Product Change Notice (PCN)

PCN Number: PCN-0451149R-01

Product(s) Affected: PJ-037B

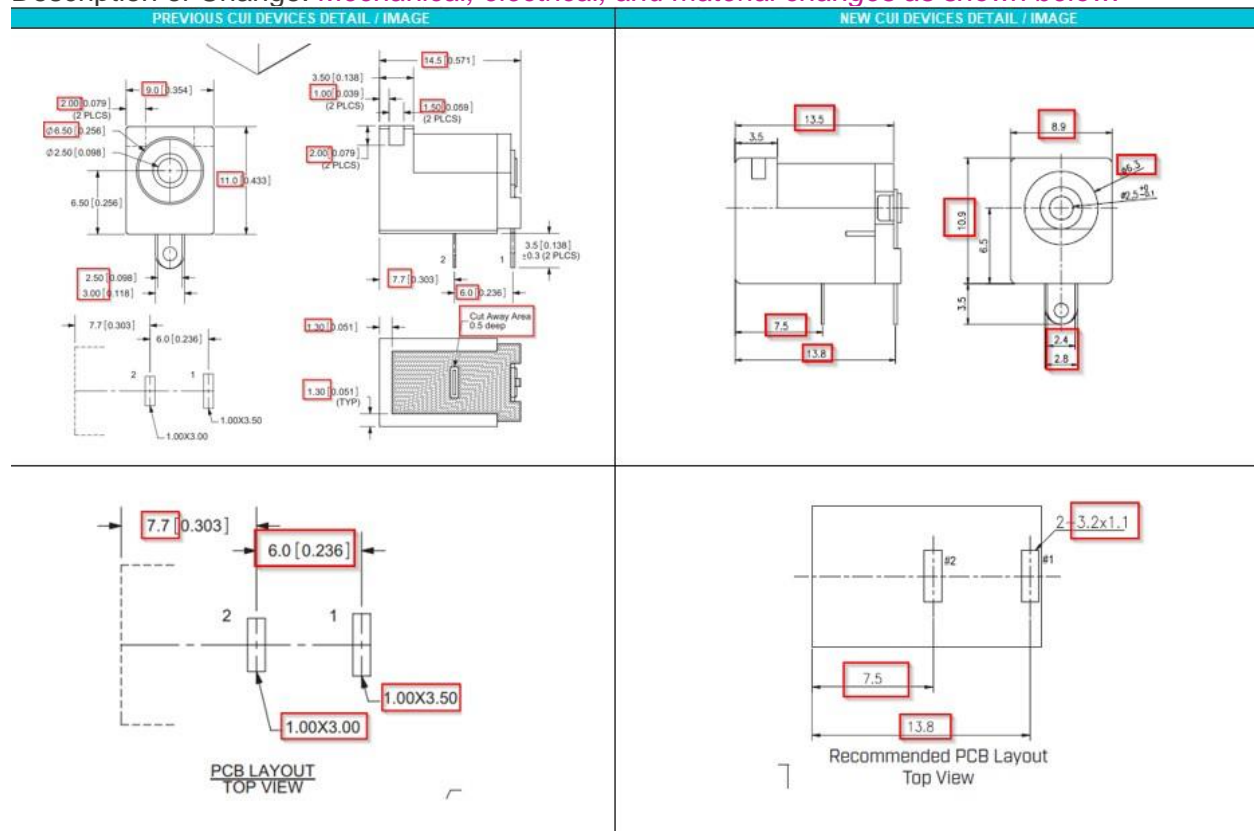
Description of Change: *Mechanical, electrical, and material changes as shown below:*

MATING PLUG
Jack Insertion Depth: **9.0 mm**

MATERIAL	PLATING
center pin	copper	nickel
terminal 1	brass	tin
terminal 2	copper alloy	tin
plastic	PBT

Insertion/Extraction force adjusted to 0.3 ~ 2.0Kg

MATING PLUG
Jack Insertion Depth: **9.8 mm**

DESCRIPTION	MATERIAL	PLATING/COLOR
center pin	copper alloy	nickel
terminal 1	brass t=0.3 mm	nickel-silver
terminal 2	phosphor bronze t=0.3 mm	nickel-silver
housing	PBT (UL94V-0)	black
cover	PBT (UL94V-0)	black
